UNITED STATES  
DEPARTMENT OF THE INTERIOR  
BUREAU OF LAND MANAGEMENTFORM APPROVED  
OMB NO. 1004-0137  
Expires: January 31, 2018**SUNDRY NOTICES AND REPORTS ON WELLS**  
**Do not use this form for proposals to drill or to re-enter an**  
**abandoned well. Use form 3160-3 (APD) for such proposals.****Carlsbad Field Office**  
**OCD Artesia**  
Bureau No.  
NMNM19246

☒ Oil Well ☐ Gas Well ☐ Other8. Well Name and No.  
NASH UNIT 47H

While drilling the 10-5/8" 2nd Intermediate, the BHA twisted off at a bit depth of approximately 6,934'. After fishing operations, the top of the fish was reduced to 6,756' (178' of fish). XTO Energy Inc. respectfully requests the expedient approval of the following sidetrack procedure.

# Vertical Schematic - Casing & Cement

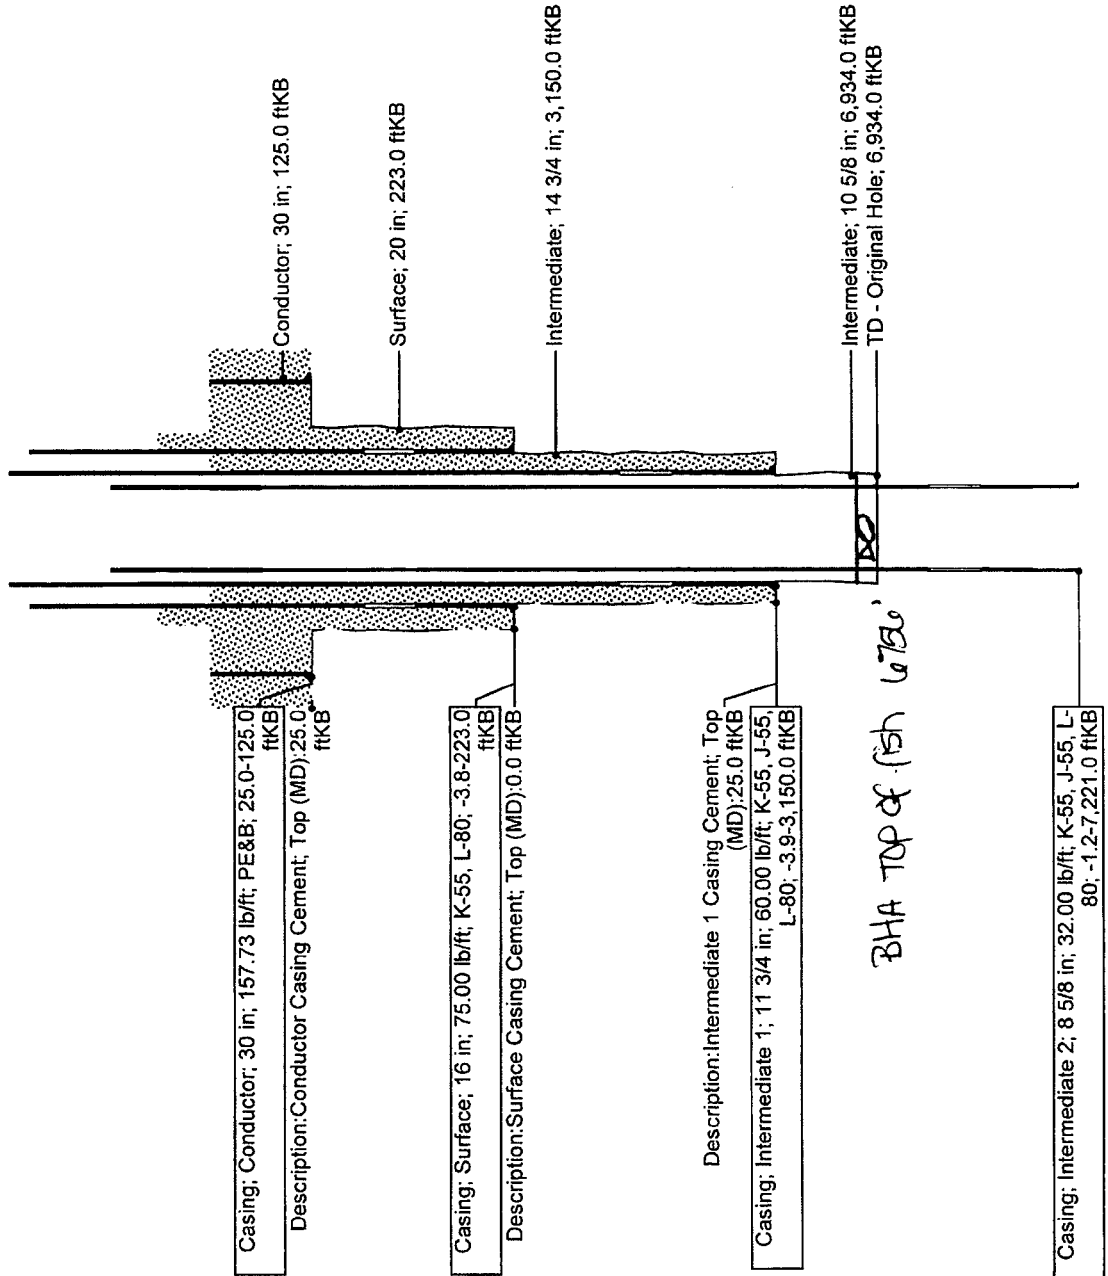
Kick-off Plug: +/- 525 sacks of 17.5 ppg cement will be pumped through a tubing stinger from 6,725' to 6,025'. Cement details: Yield: 0.951 ft<sup>3</sup>/sack Water: 3.48 gal/sack Weight: 17.5 ppg

Intermediate Casing Cement: 25% excess will be added to the lead due to the time spent fishing.

The 8-5/8" casing design from the latest sundry will still be run to  $\pm 7,200'$  TVD.

-All previous COAs still apply. Additional COA is not required.
